ORIGINATION FORM

Proposed Revisions to a Standard Plans Index
(Please provide all information — Incomplete forms will be returned)

Index Number: 695-001
Sheet Number (s): 1 through 7
Index Title: Traffic Monitoring Sites

Index Number: 695-001
Sheet Number (s): 6-7
Index Title: Traffic Monitoring Site

CABINET LAYOUT DETAILS (Four Lanes or Less)

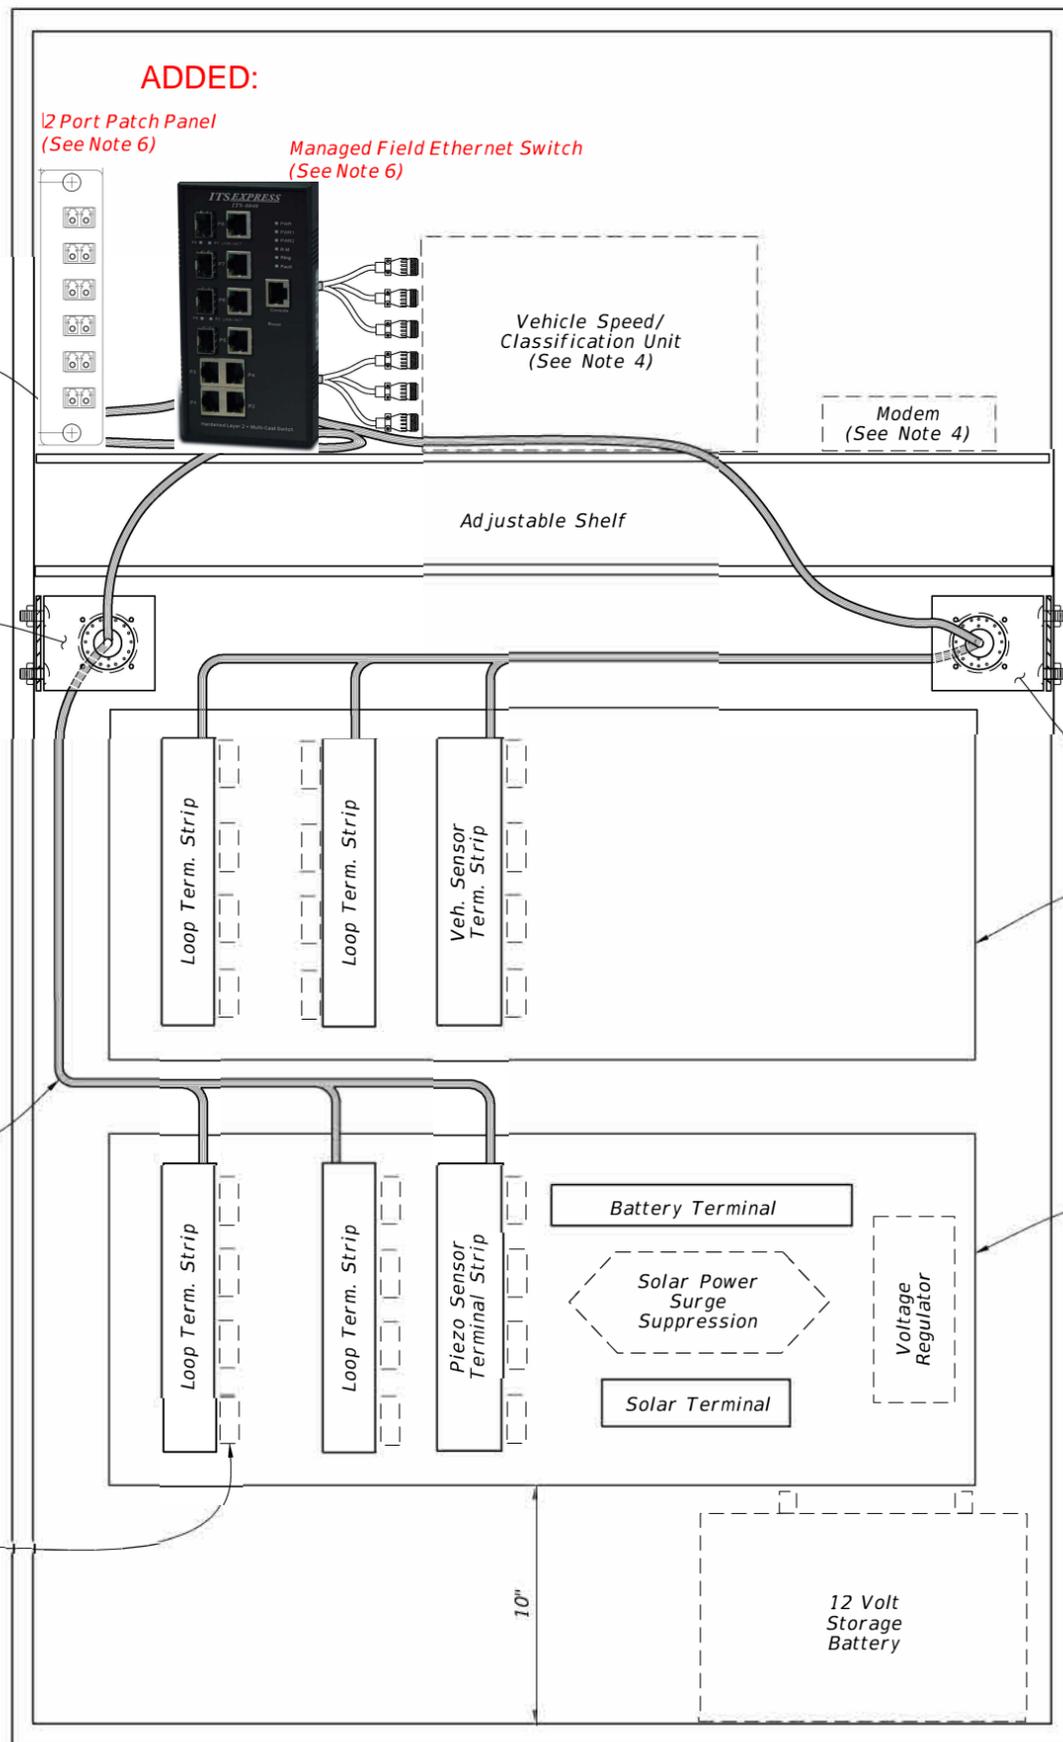
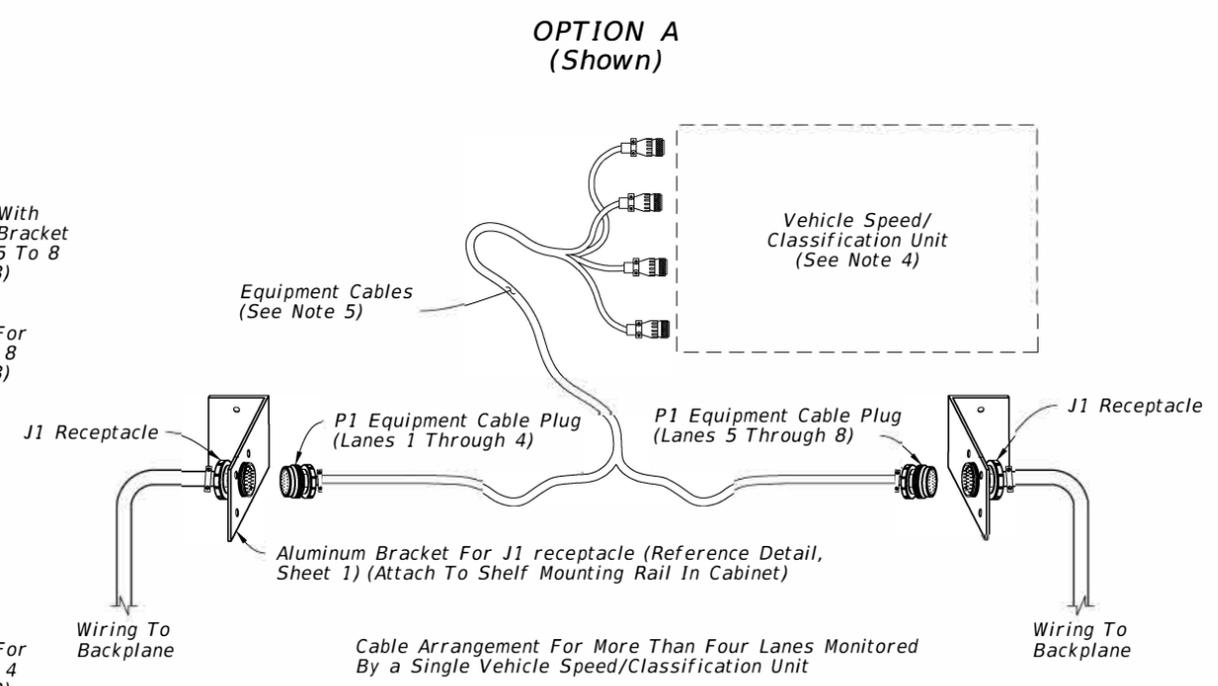
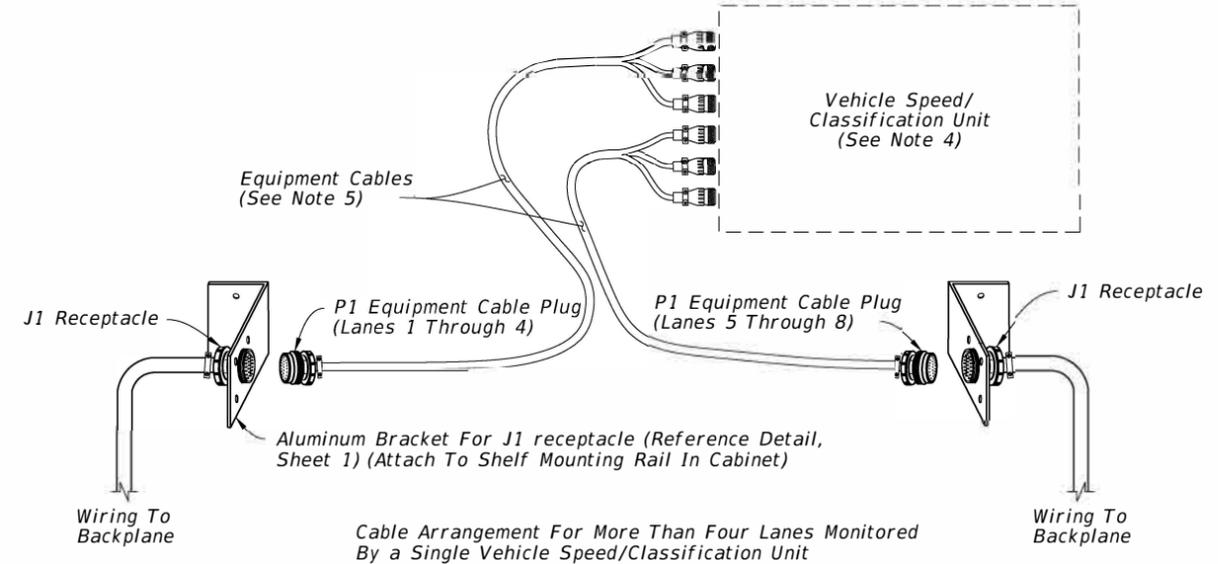
CHANGED TO: Data and Analytics

ADDED: Note 6

CABINET BACKPLANE DETAIL

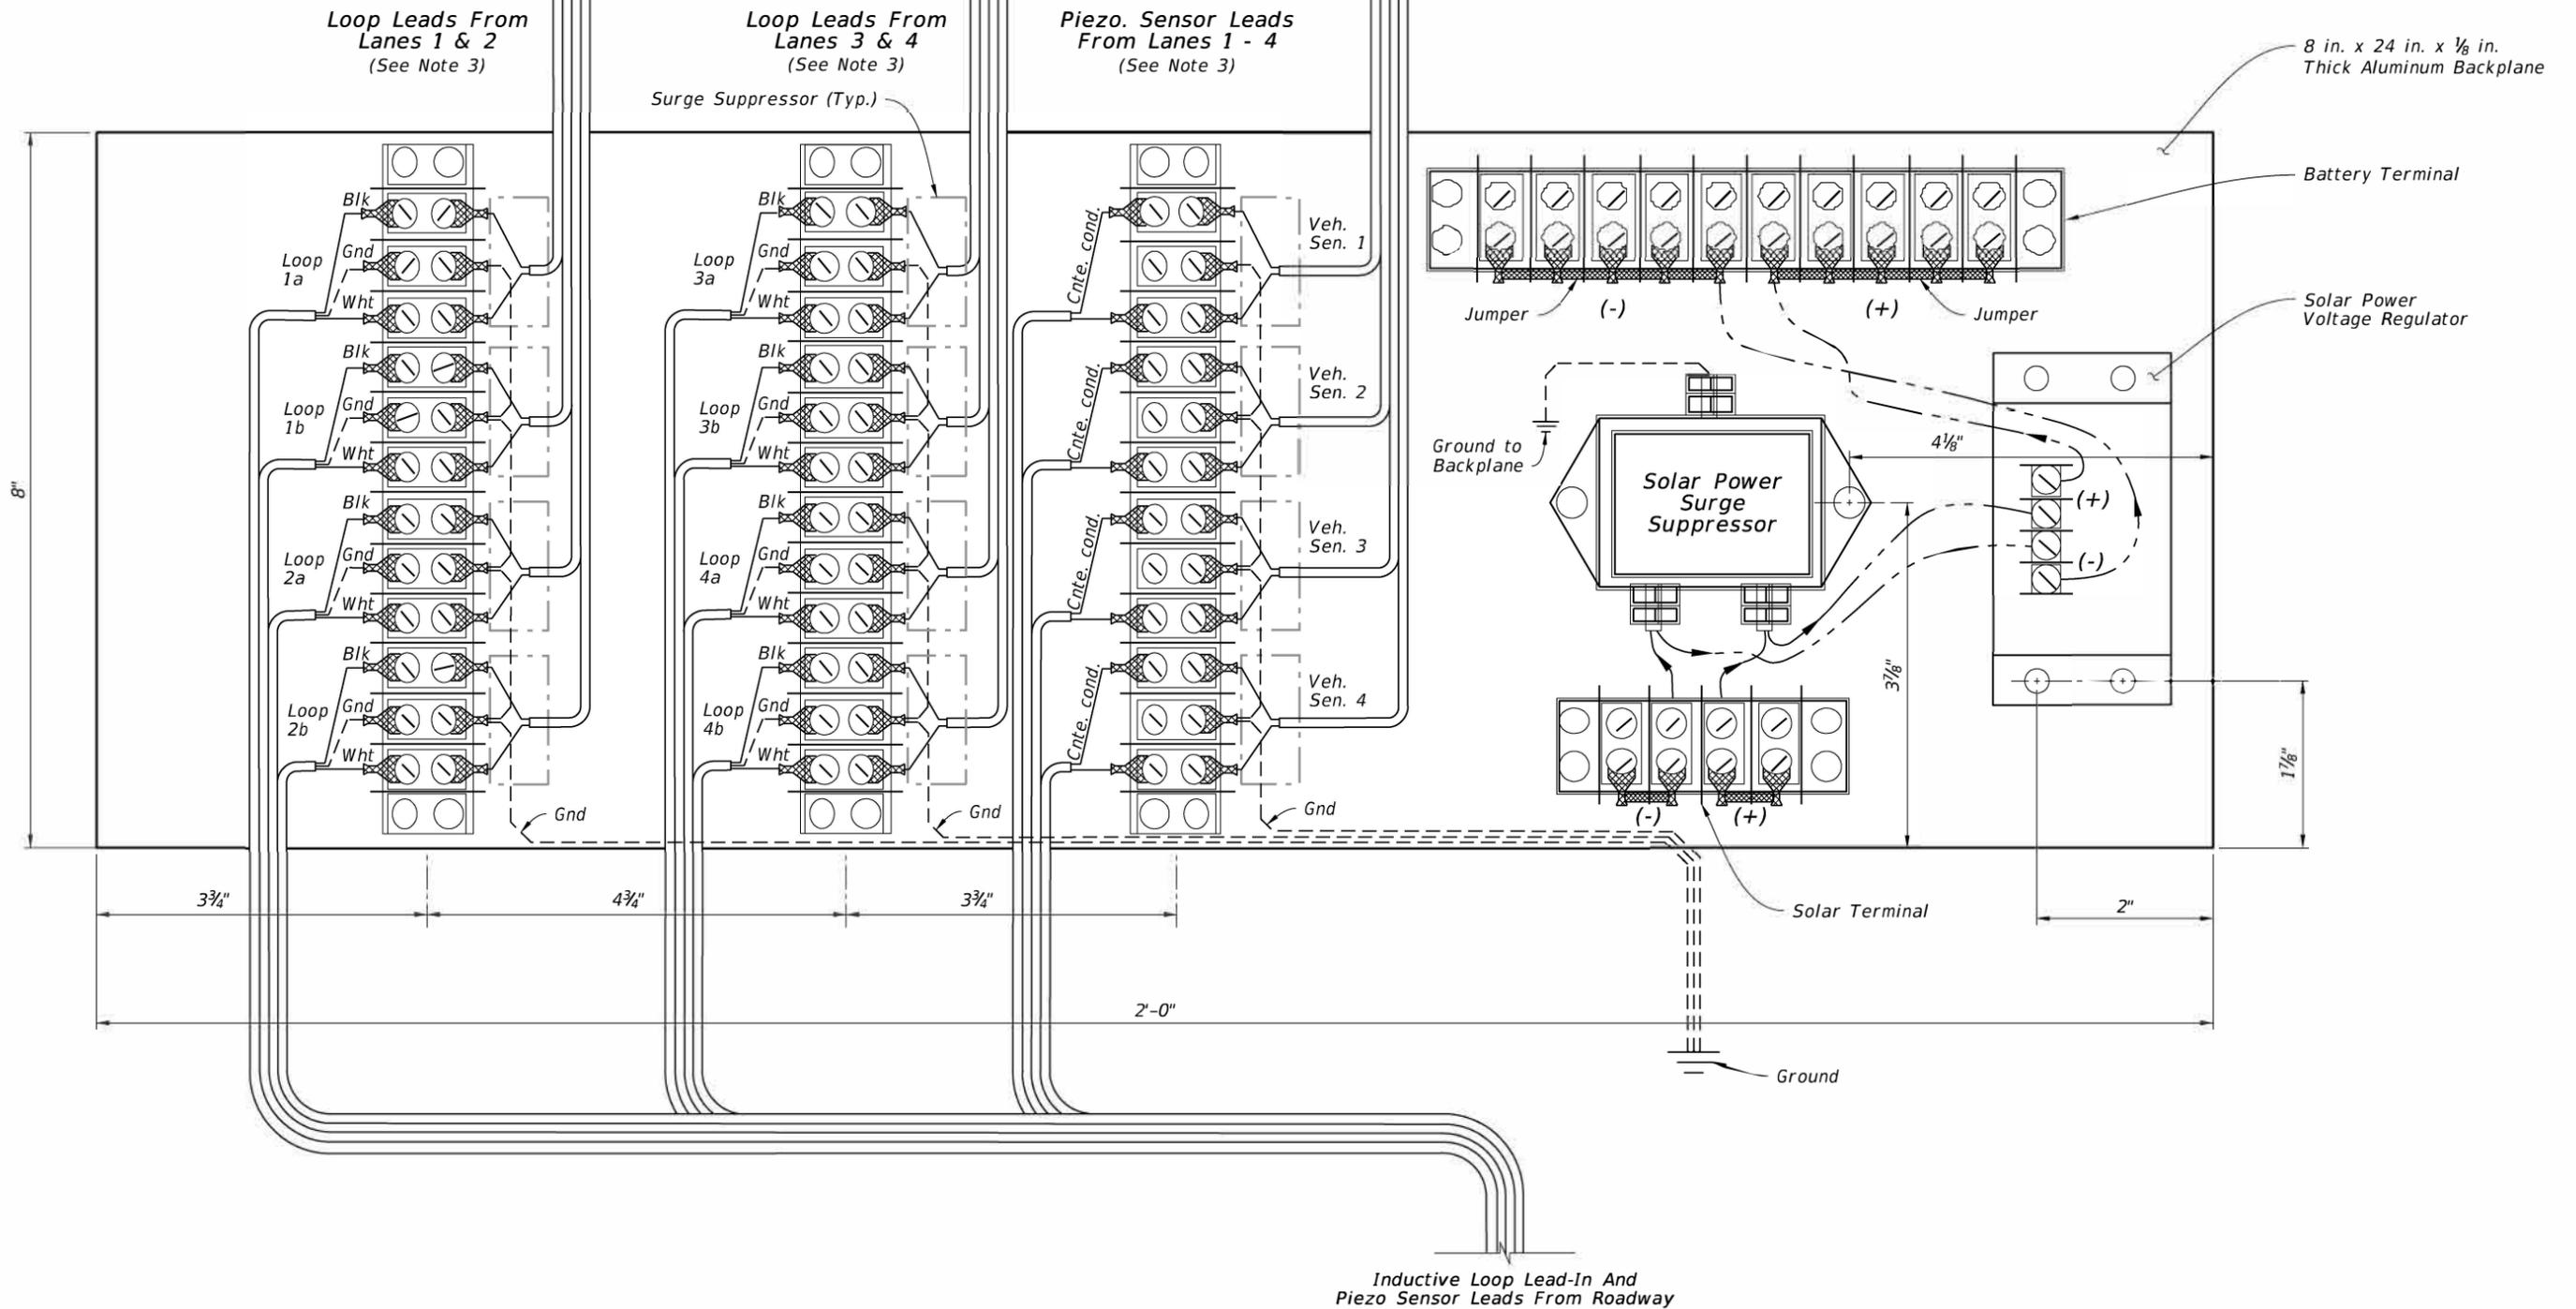
CHANGED TO: Data and Analytics

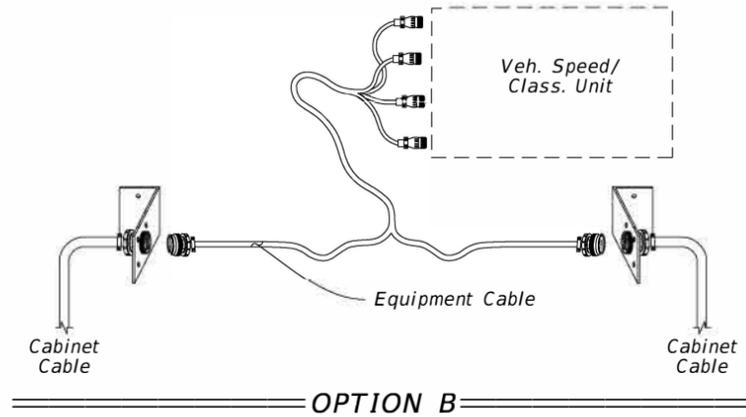
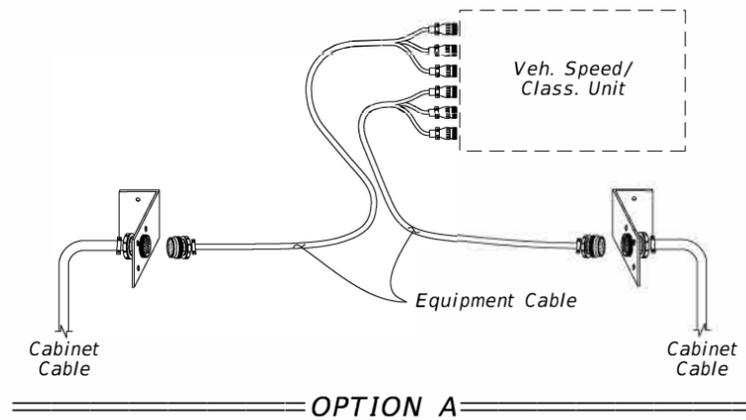
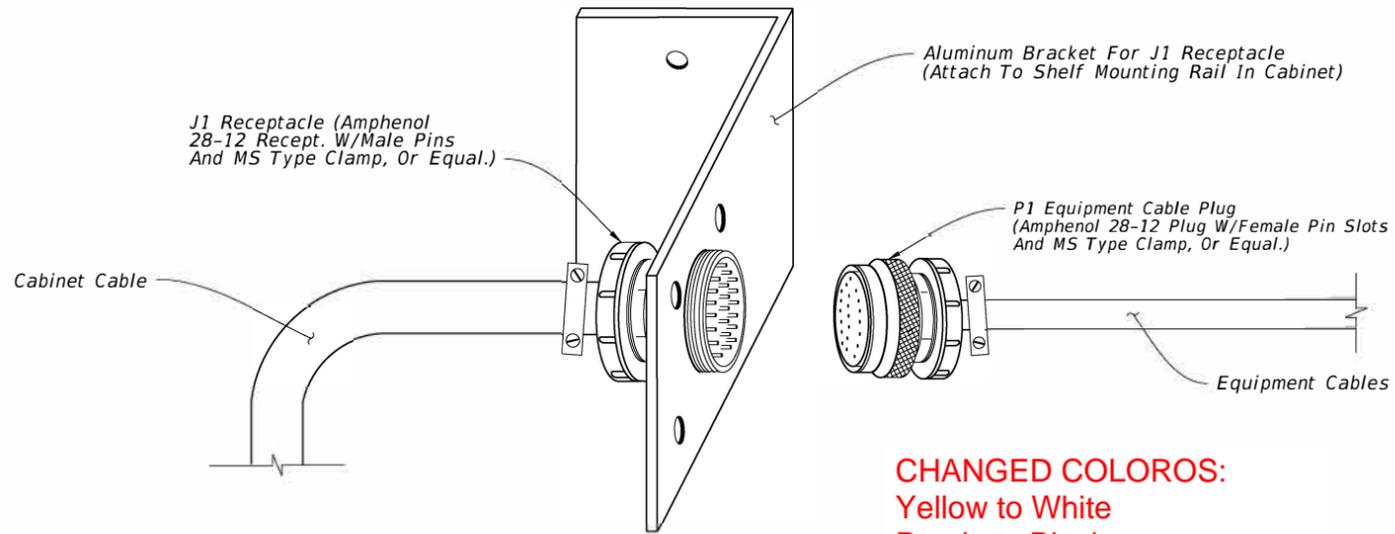
CHANGED COLOROS:
 Yellow to White
 Purple to Black
 Gray to Red
 Pink to Black
 Brown to Green

CHANGED TO: Data and Analytics

CHANGED TO: Green

LANE CONFIGURATION FOR TMS INDUCTIVE LOOP AND QUARTZ PIEZO AXLE SENSOR

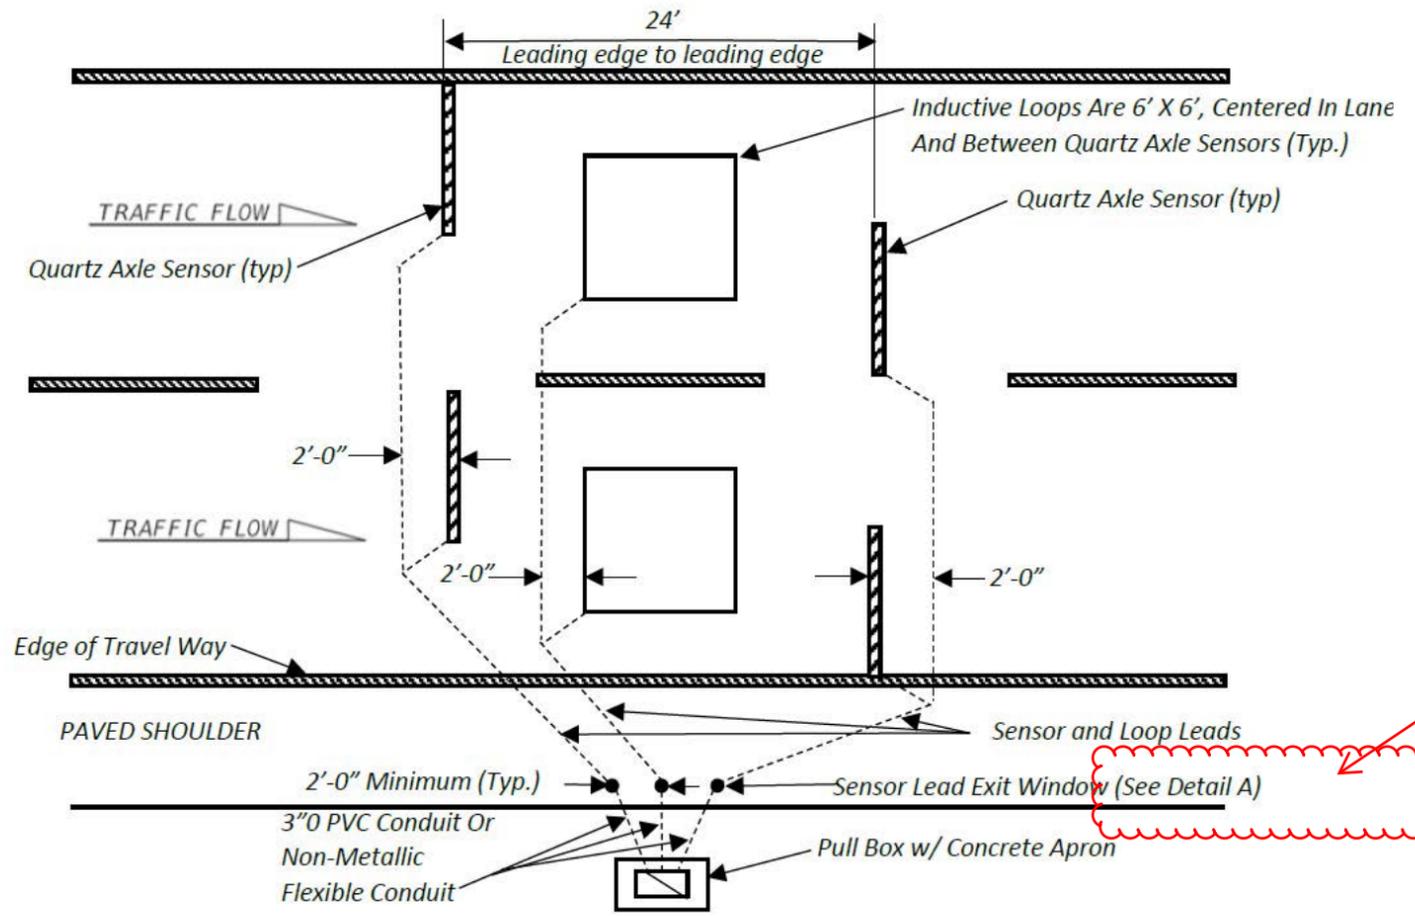
NEW SHEET 6
